Responses to the comments of Reviewer #1:

Responses to the comments of Reviewer #2:

Figure 1. Flowchart of the computation of surface layer variables in the WRF model.

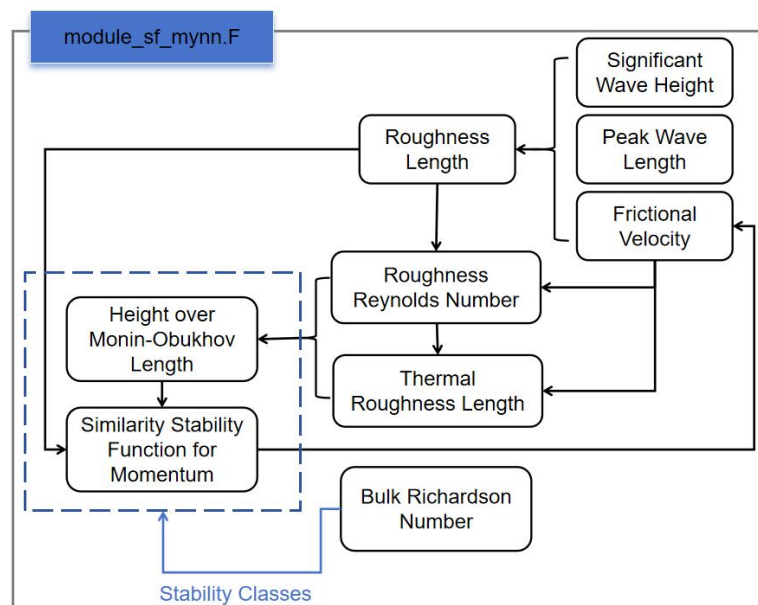
1. Inflow wind speed in FWP: in Sect. 5.1, the authors propose an inflow wind speed to the turbine $V_{ijk|wt}$ that differs from the horizontal wind speed in the grid cell V_{ijk} . It is not clear how the inflow wind speed $V_{ijk|wt}$ is derived from V_{ijk} . The authors provide a short explanation on why $V_{ijk|wt}$ differs from V_{ijk} in Lines 312-315. Perhaps a flow chart like Fig. 1 in DOI: 10.1175/MWR-D-20-0097.1 comparing the FWP and Fitch WFP might help clarify this point.

Response: That's a good comment. A more detailed explanation is needed to give the reader an idea of what factors influence the change in the inflow wind speed. The largest uncertainty comes from the surface parameterization scheme (module_sf_mynn.F) in the WRF model. The attenuation of the effective wave height by the floating platform leads to changes in a number of variables that together determine the (inflow) wind speed (Figure 1). We have added this in lines 312-315 of the revised manuscript.
